Subject: SES Solar Two (08-AFC-5)
Responses to CEC and BLM Data Requests 128-141
URS Project No. 27657106.00608

**In Response to CEC & BLM Data Requests 128-141
Set 2, Part 1
Application for Certification (08-AFC-5)
SES Solar Two, LLC**

SES Solar Two
In Response to CEC and BLM Data Requests
Set 2, Part 1
Data Requests 128-141
08-AFC-5

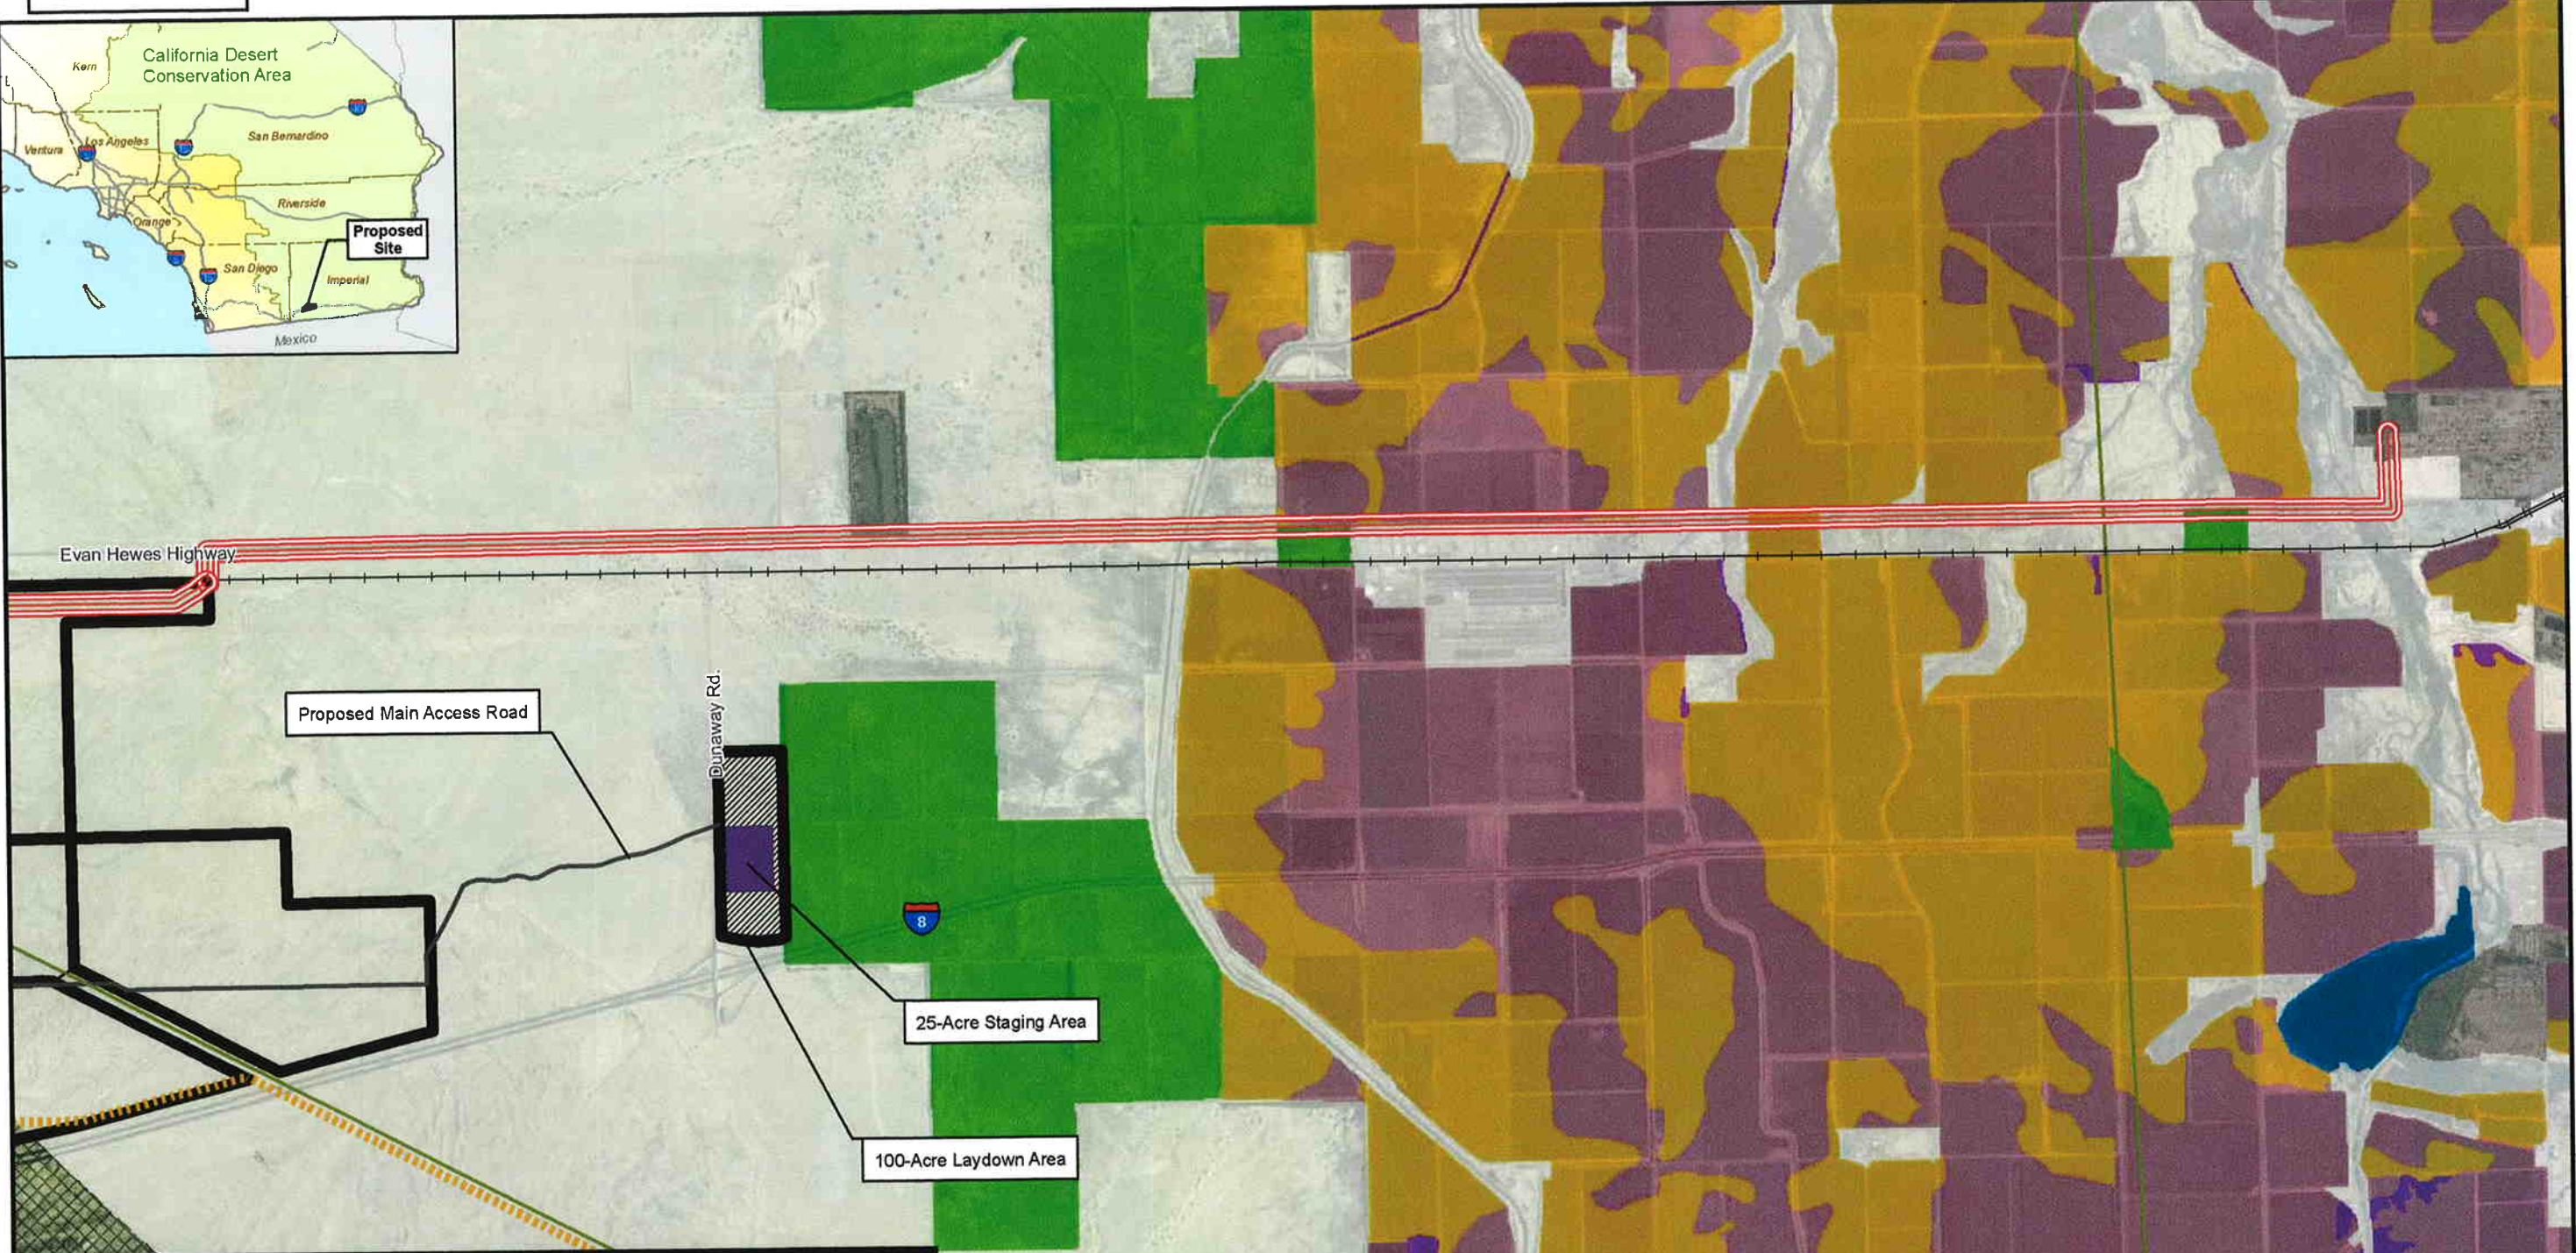
Data Request 136: Please verify whether construction of this pipeline would occur in the area proposed in AFC Figure 5.9-2.

Response: The construction of the pipeline as shown in Figure 5.9-2 has been updated to use reclaimed water from the Seeley Wastewater Treatment Plant. The Applicant is scheduled to docket a supplemental filing (Q2 2009) to include a description of the new water source which will include a description and figures of the new waterline location.
